SI B33 03 14
Rear Axle

SB-10056094-2346

Service Action/Delivery Stop: Rear Shock Absorber Guide Support

F15 (X5)

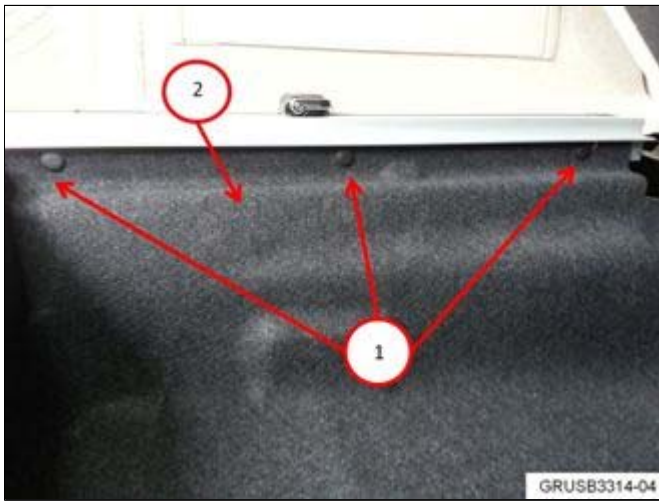
Some rear shock absorbers may have been assembled with the incorrect guide support. These incorrect guide supports will cause a rattling noise within a low mileage.

Check **both** guide supports and replace if the wrong part number parts are found.

Correct part number: 6 851 881

Incorrect part number: 6 867 864

<p>Raise the luggage compartment floor. Remove the expanding rivets (1) from the left and right side of the luggage</p>
--	---

compartment pan (2) to expose the shock absorber guide support.

Check the parts label on the guide support.

If the incorrect guide support is installed, replace it per Repair Instruction 33 52 161.
